SB-10045301-9385

December 2012 Technical Service

Service Action: Retrofit of the Engine Coolant Temperature Sensor

R60 with manual transmission (N16 or N18 engine)

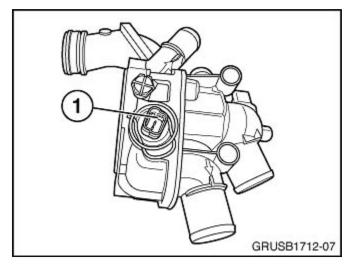
Procedure One requires the replacement of the upper coolant hose with a modified hose that houses a new engine temperature sensor. An adapter harness needs to be fitted to the car to utilize this new sensor.

Procedure Two requires the installation of a new engine temperature sensor, with integrated wire harness, installed in place of the thermostat bleeder screw.

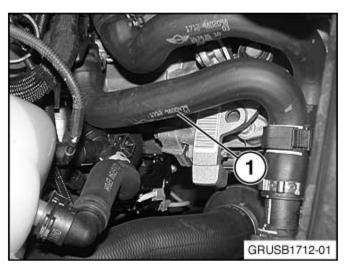
Checking for updated thermostat: The 11 53 7 534 521 thermostat has a replaceable engine temperature sensor (1).

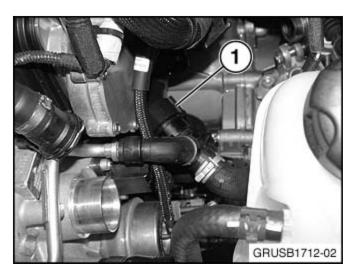
Remove the fresh air intake tube and the charge air intake tube from the air box to the turbo to gain access to the coolant hose.

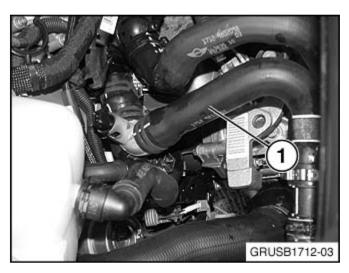
N18 engine only! Install spacer P/N 64 53 7 578 707 (1) on the coolant line as shown.

Note: The spacer needs to stay in this position when installing coolant hose P/N 17 12 9 811 352 (next step).

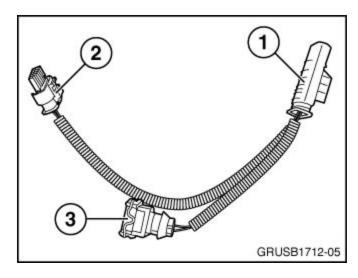
Install the new coolant hose with sensor P/N 17 12 9 811 352 (1).

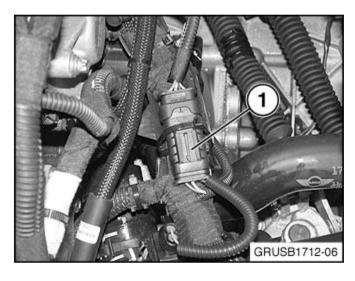
Unplug connector X6279 from the engine thermostat (1).

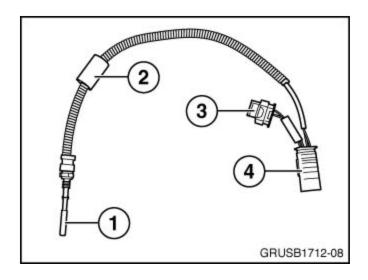
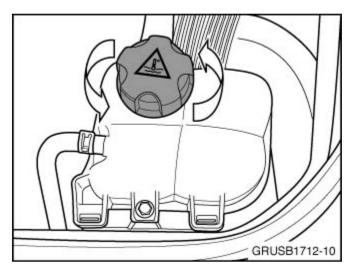
Plug connector X6279 into the 4-pin male connector (1) of adapter harness P/N 12 51 7 647 200. Insert the 4-pin female connector (2) of the adapter harness into the engine thermostat. Plug the 2-pin female connector (3) from the adapter harness into the engine temperature sensor of hose P/N 17 12 9 811 352.

Secure the connector (1) with a cable tie to the engine wiring harness.

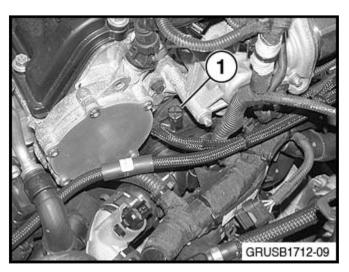
The improved sensor (PN13 62 8 603 908) includes the temperature probe (1) and insulating sleeve (2), a two-pin female connector (3) for the map thermostat and a four-pin connector (4) for the engine harness

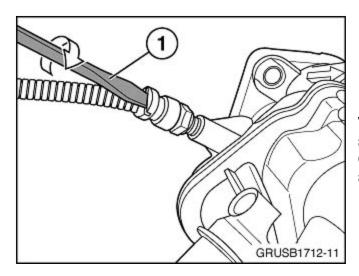
Relieve the coolant pressure by removing the reservoir cap and then retighten.

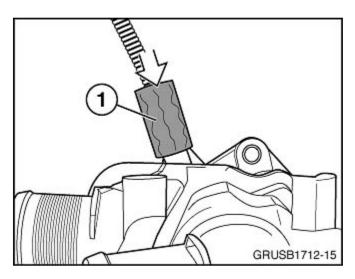
Remove the bleeder screw (1) from the thermostat. This screw will not be reused.

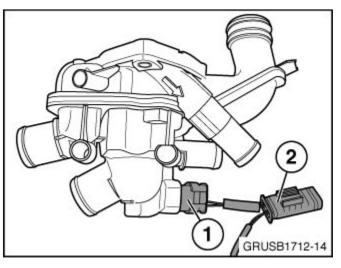
The back of the temperature sensor is slotted to accept a bladed screwdriver (1). Install the sensor into the bleeder screw hole and torque to 2Nm.

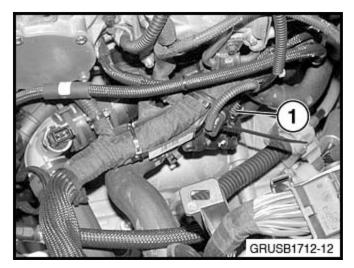
Slide insulating sleeve (1) onto the temperature sensor. The sleeve must completely cover the sensor.

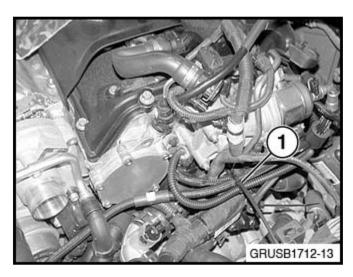
Install the two-pin female connector (1) into the thermostat and the four-pin male connector (2) into the engine wiring harness.

Secure the connector (1) with a cable tie to the engine wiring harness.

Secure the wiring from the temperature sensor (1) with a cable tie.
